LIC-84-087

Reference: Docket No. 50-285

Fort Calhoun Station
Cycle 9 Core Reload Submittal

Figure 1

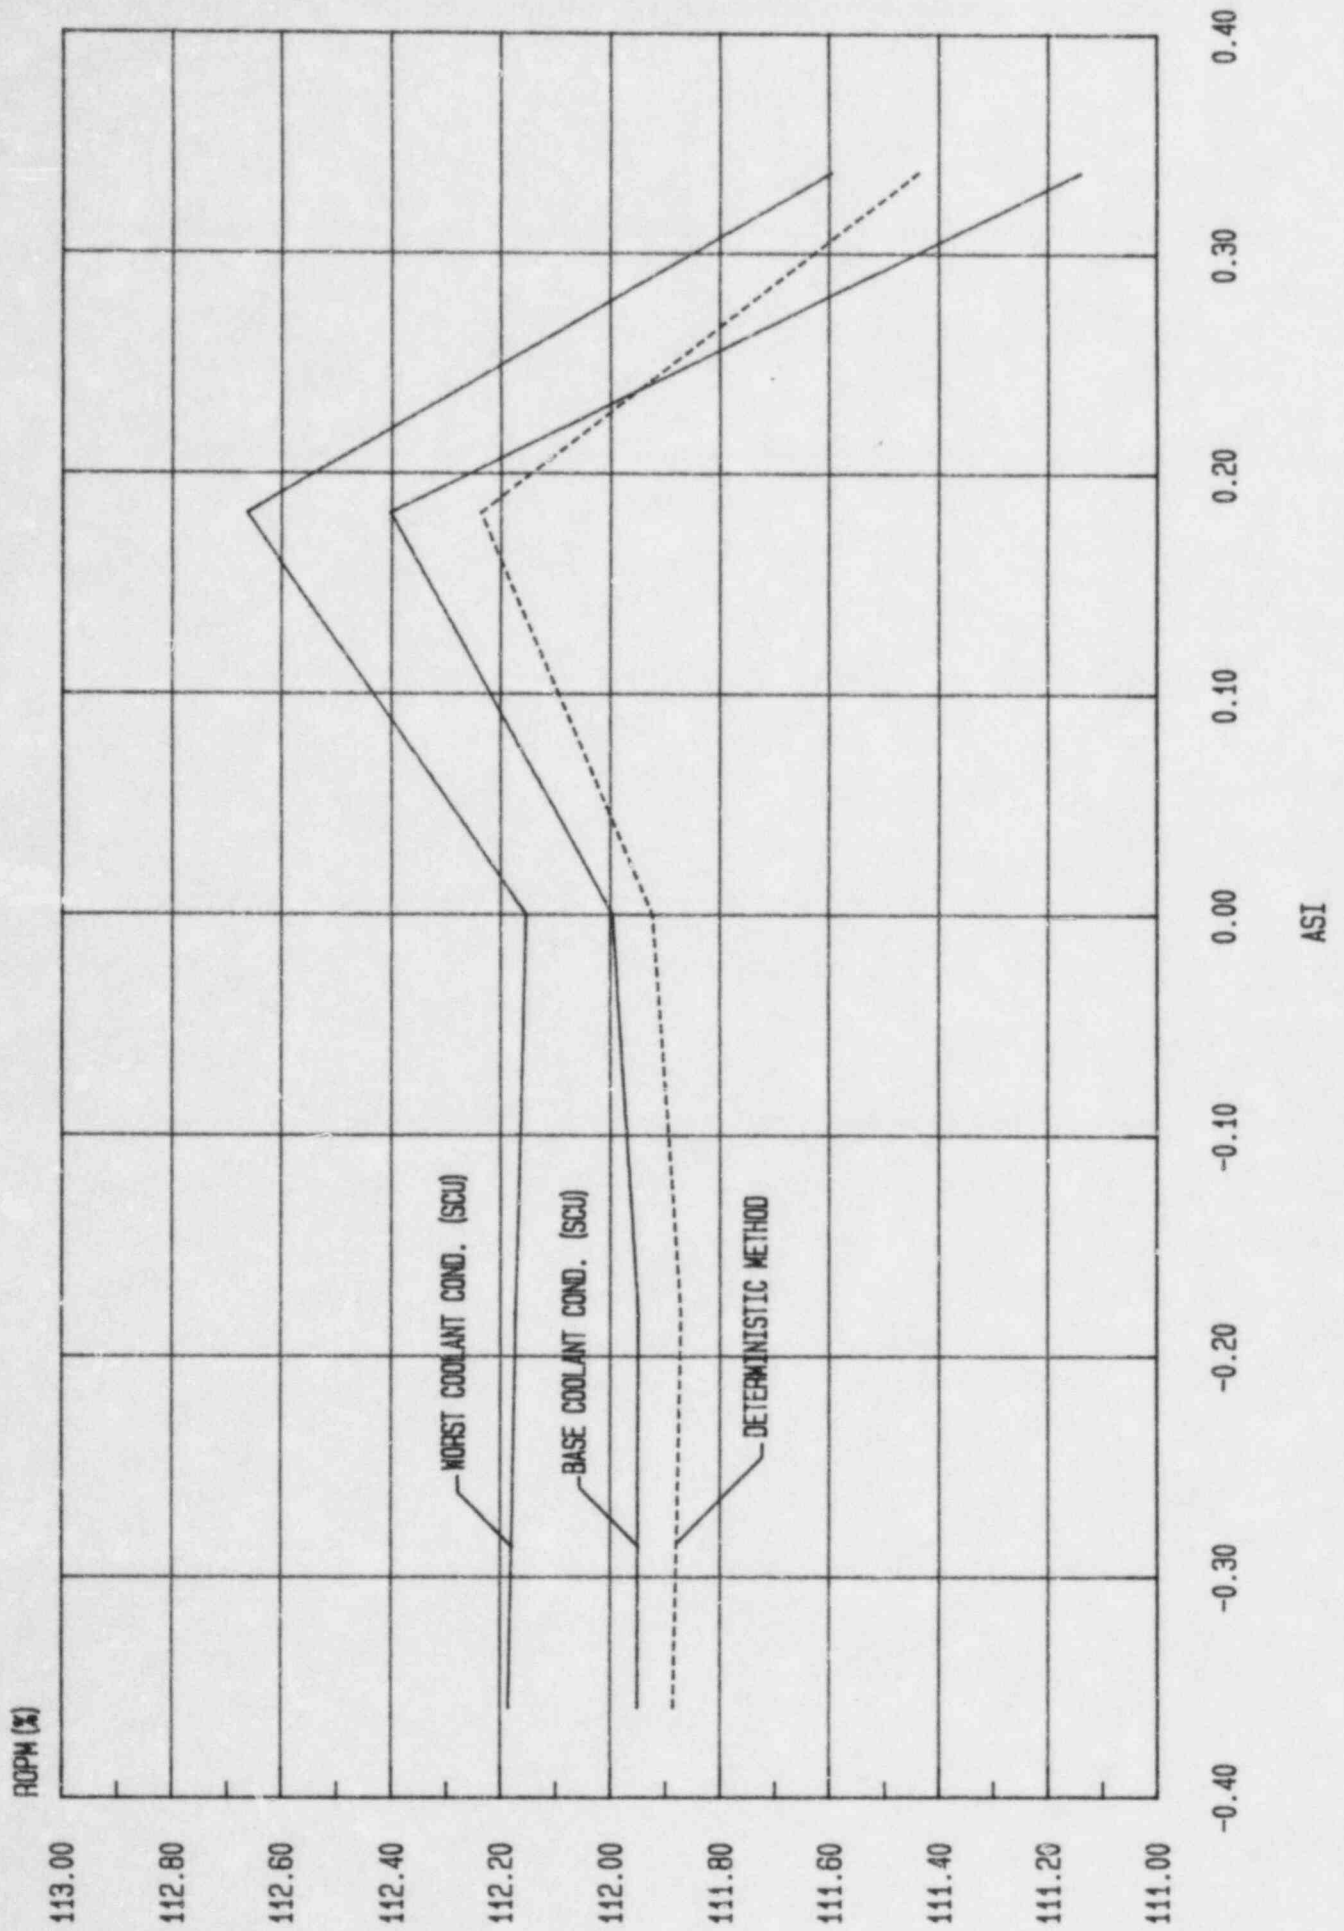
NRC Question 7: For those events in which a lower (RCS) flow rate results in a more conservative analysis, justify the use of 208,280 gpm rather than the Technical Specification value of 202,500 gpm.

The transient analysis for the SCU program included a comparison between the SCU derived worst coolant condition ROPM and an ROPM derived using the deterministic combination of the uncertainties. The attached Figures 1 and 2 show this comparison and the SCU base coolant conditions ROPM. These figures show that the deterministically calculated ROPMs are always bounded by the SCU worst coolant conditions case. It should also be noted that the SCU base coolant condition ROPMs are often more restrictive (i.e., larger) than the deterministically calculated values.

Based on Figures 1 and 2, it can be concluded that use of the 208,280 gpm RCS flow rate, for the CEA Drop and Loss of Coolant Flow events for Cycle 9, in conjunction with the SCU methodology, generates ASI dependent ROPM values which are conservative with respect to those which would be generated through the use of deterministic methods utilizing the RCS flow rate Technical Specification limit of 202,500 gpm. The use of the best estimate flow of 208,280 gpm is justified because the flow uncertainty is accounted for in the Δ ROPM function which is added to the ROPM calculation which used the best estimate flow (i.e., base coolant conditions) and because the ROPM for the worst coolant condition case (base coolant condition case plus Δ ROPM function) is conservative with respect to the deterministic method case.
